DELEGATED APPLICATION REPORT

App Ref: PL/26/0479 Full planning permission

Address: 20 COLDICUTT STREET, CAVERSHAM, READING, RG4 8DU

Proposal: Change of use of the ground floor of 20 Coldicutt Street from Class E (Retail) to Class C3 (Residential) to create x1 bedroom self-contained ground floor flat. Reconfiguration of existing first floor flat in C3 use to provide self-contained 2 bedroom maisonette across the ground, first and second floor, with a new main rear access proposed for the 2x bedroom flat.

9520 PL-04.01 Proposed site plan

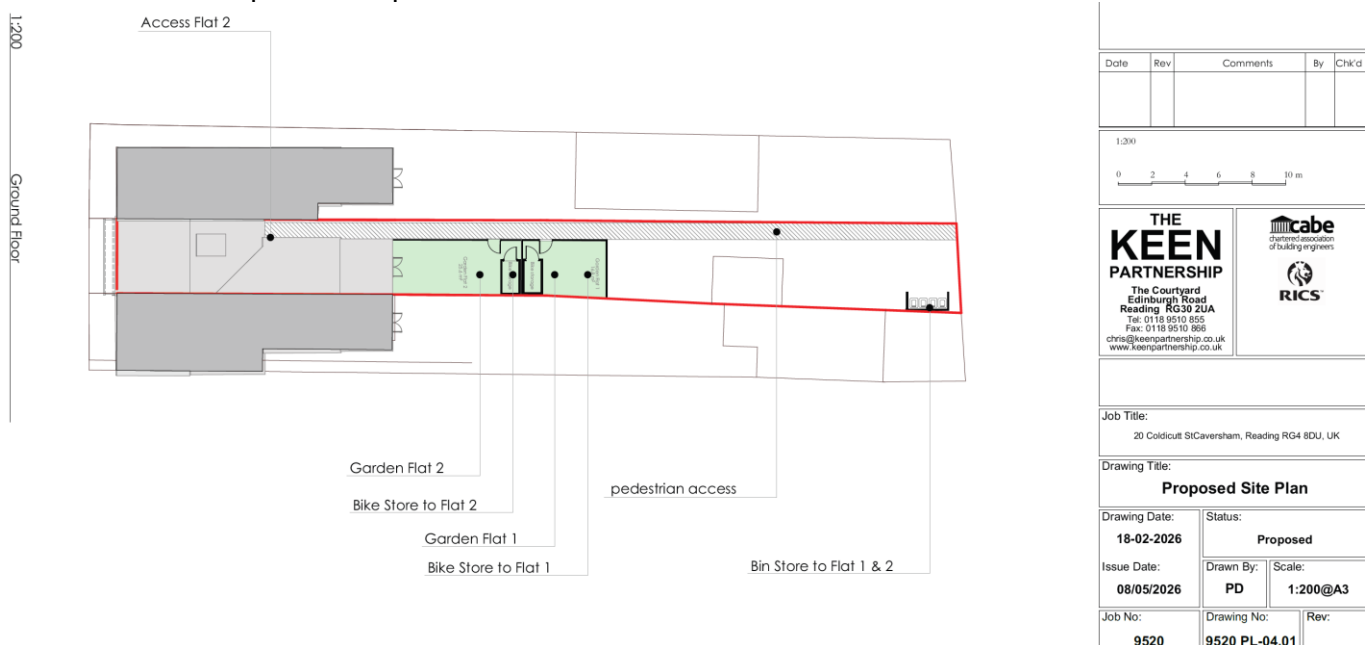
Bin stores and cycle provision are proposed at the rear, with a proposed external garden area for each flat which includes part of the existing rear garden only as can be seen in the 9520 PL-04.01 Proposed site plan below.

I note on the proposed site plan document there is space drawn for 4 bins of unknown size or waste type.

Please ask that consideration be made for all of the above required bins and confirm that there is dedicated space for them all within the boundary of the property.

It seems that all bins are planned to be stored at the rear of the property. Please confirm if this is correct? Is there rear access at the property to enable bins to be collected from there? Please note that residents are required to present their bins for collection at the curtilage of their property for collection. Crews would not enter secure front/rear gardens directly to retrieve bins.

Is the space at the rear also designated for parking? Will the presence of vehicles obstruct access to the bins on collection day?

The proposed block plan does not use all of the land to the rear of the building within the red line. There is an unused space in front of the rear outbuilding that is unused space and has not been incorporated into external garden amenity indicated on the site plan for either of the flat units. The street is characterised

9520 PL-04.02 Proposed ground floor plan

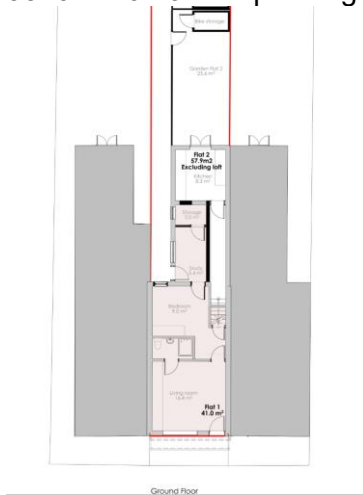
No daylight and sunlight assessment has been provided to evidence that there would be sufficient provision of daylight and sunlight into each habitable room in Flat 1. There would be a poor outlook from the ground floor bedroom and study overlooking a rear alleyway and boundary fence. The rear bedroom of Flat 1 only has a small high level window which is not considered to provide adequate daylight into the bedroom (as shown in above elevations 9250 PL-04.06 Proposed elevations and 9520PL-04.02 Proposed Ground floor plan floor plans). It is not considered to provide an acceptable standard of residential accommodation Although windows are shown on floor plans to the study and storage cupboard, with a rear side door, no windows or door are shown on the proposed side elevations and inconsistent information has been submitted.

Geo26-009 Level survey

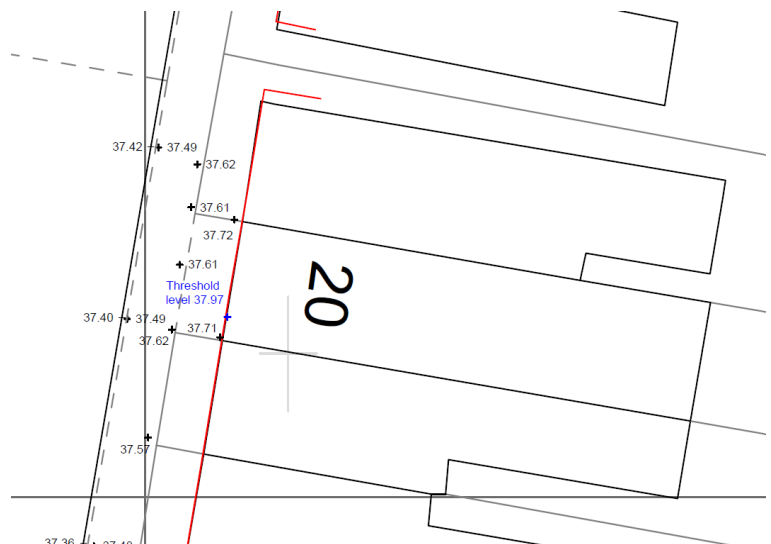
The Geo26-009 plan submitted shows that the threshold level at the front of 20 Coldicott Street is 37.97 and no levels have been provided to the rear of the property or at the end of the rear access. It is unclear whether the levels would be the same for both Flat 1 and Flat 2 which only has access to the rear of the site. The amended rear access for Flat 2 has been moved from the side of the building to the rear elevation further into the 3b functional flood zone. No separate analysis has been provided for each flat and no section plans have been provided for the existing and proposed ground floor levels at 20 Coldicott Street. Inside the living room of Flat 1 on the ground floor, there was a step height difference in the corner of the front room, and the internal ground floor is not at a consistent level. It is unclear whether the floor level proposed will be acceptable in the longer term.
